SERVICE BULLETIN

RS17-006b
 NTB17-025b
 August 10, 2017

2013 – 2016 PATHFINDER OCCUPANT CLASSIFICATION SYSTEM RETROFIT

APPLIED VEHICLES: 2013 – 2016 Pathfinder (R52)

Figure 3

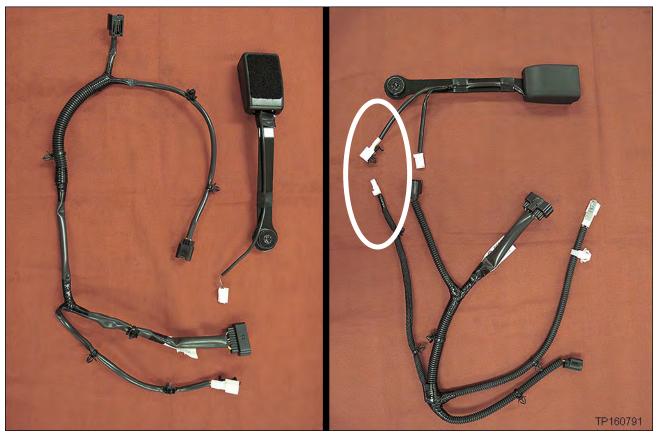
EXAMPLE

Old OCS harness and seatbelt buckle are removed.

EXAMPLE

New OCS harness and seatbelt buckle are installed

Notice the new harness and buckle have a new branch and connector
